APPENDIX V: TLG TRANSPORTATION STUDY

Office	TLG Transport Inc 4328 CO-66 Longmont, CO 80504 (303) 678-8384 (303) 678-8714 www.tlgtransport.com	Status	For information
		Doc No	
		Date	April 2020
		Issued to	
Issued by	TLG Transport	Client	GE
Project	Horse Heaven, Pasco WA	Job No

Subject Preliminary site review (This study is for feasibility only and not to be used for permitting purposes without a physical survey being conducted by the carrier)

Horse Heaven Wind Project (Summary)

Nine Canyon North

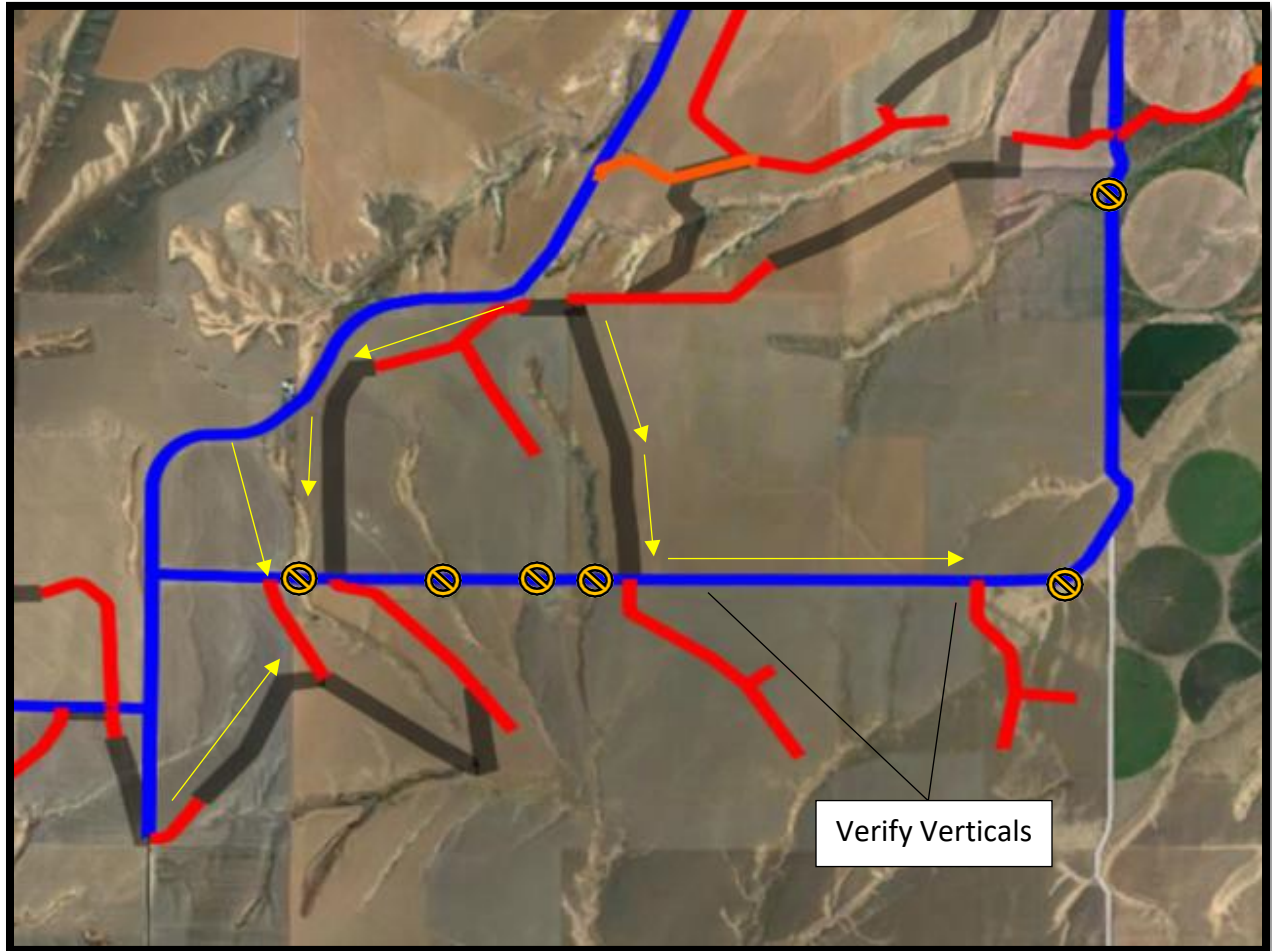
At Beck Road

- Turn cannot be completed as constructed plus incline after turn.
- Customer proposes to crossover from Nine Canyon Road to Beck Road to bypass these obstacles.
- Verify verticals out about 0.8 to 0.9 miles to last string off Beck.

Example of acute decline and inclines on Kirk

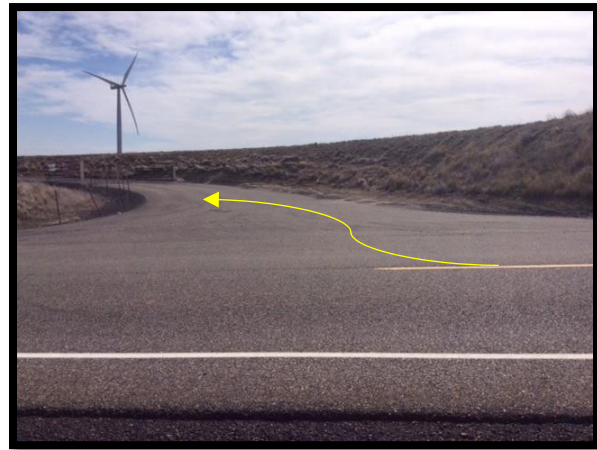
- The right turn to Kirk Road can be improved however this road has deep declines with acute inclines (See example below).
- Two vertical deviations in the first 0.3 miles before first string South.
- Recommendation is for customer to consider building new strings along knolls to avoid substantial civil improvements to Kirk Road from Nine Canyon for Western site South of Kirk or from Miles and Nine Canyon existing proposed access point for other strings.
- About 1.8 miles East of Nine Canyon Road on Kirk tie in from Miles string **verify vertical deviations meet GE specification or improve as needed.**

Access to Finley from Nine Canyon at Miles

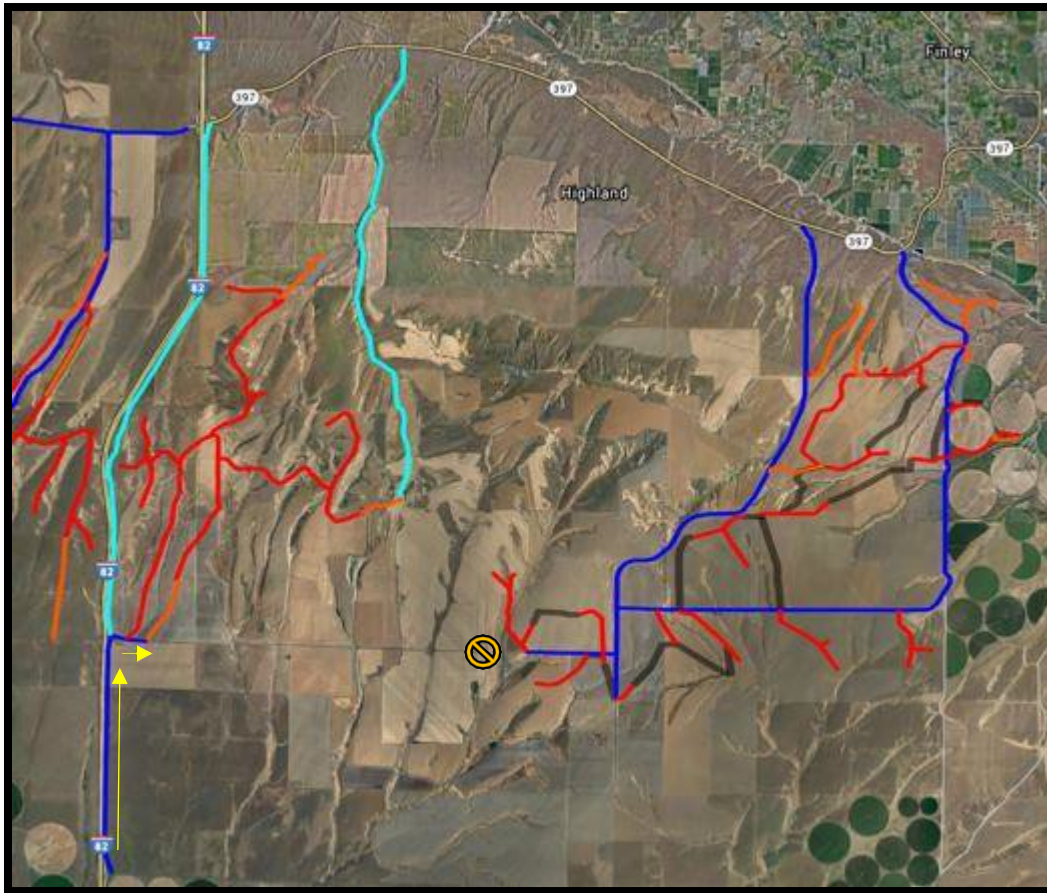
- Finley cannot be access from Kirk or 397 without significant civil improvements (grades curves etc.).
- Coming from 374 would not line up access to Northeast most string.
- Creating path from Nine Canyon at Miles with extensions of proposed strings is recommend if customer want to access the proposed sites off Finley.
- (Stop – Return to Coffin and Bofer Canyon Road).

Coffin left turn to Bofer Canyon Road

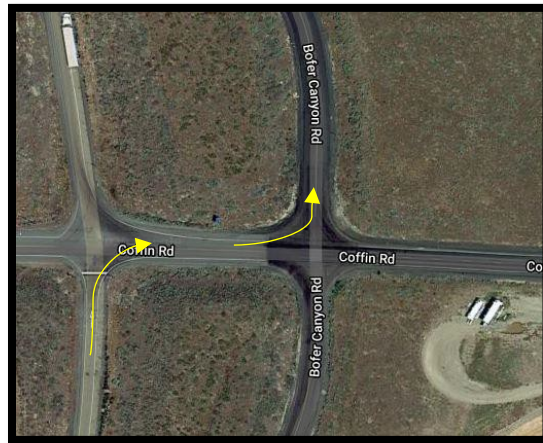
- Signs will need to be modified to removable.
- Radius improvements to GE specifications will be needed.
- Cut slopes inside turn and rear sweep (TBD by civil engineering designs within GE specifications).

Boyer Canyon Road to Beck

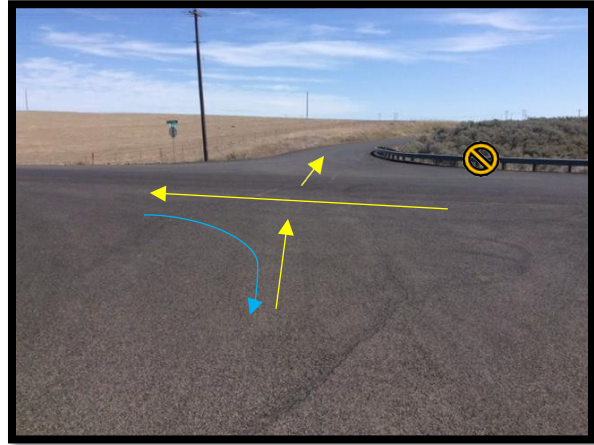
- Signs will need to be modified to removable.
- Radius improvements to GE specifications will be needed in NW corner.
- NE and SE corner has guard rail and deep ditches.
- 3 point turn will need to be approved by GE and their carriers.

At Niconson

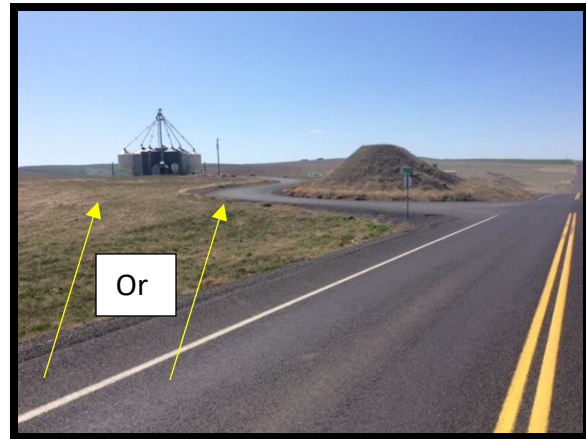
- Signs will need to be modified to removable.
- Radius improvements to GE specifications will be needed.
- Will need use of outside radius to avoid power pole in rear sweep.

At H Smith 8.7 miles West of I-82 Interchange (reviewed for 0.4 miles)

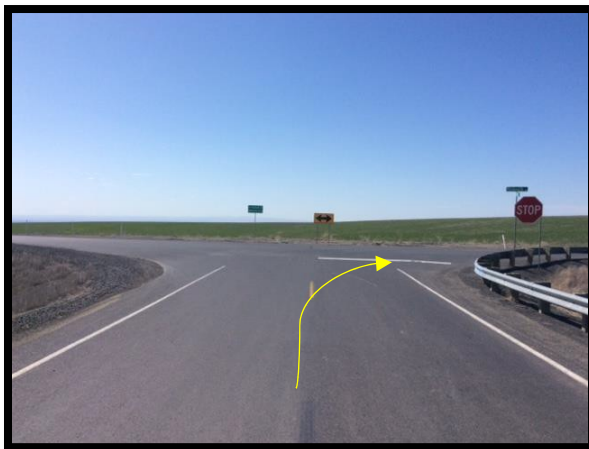
- Improve turn to GE specifications as necessary to accommodate all components for selected platform.
- 0.2 miles vertical deviation (customer plan?)
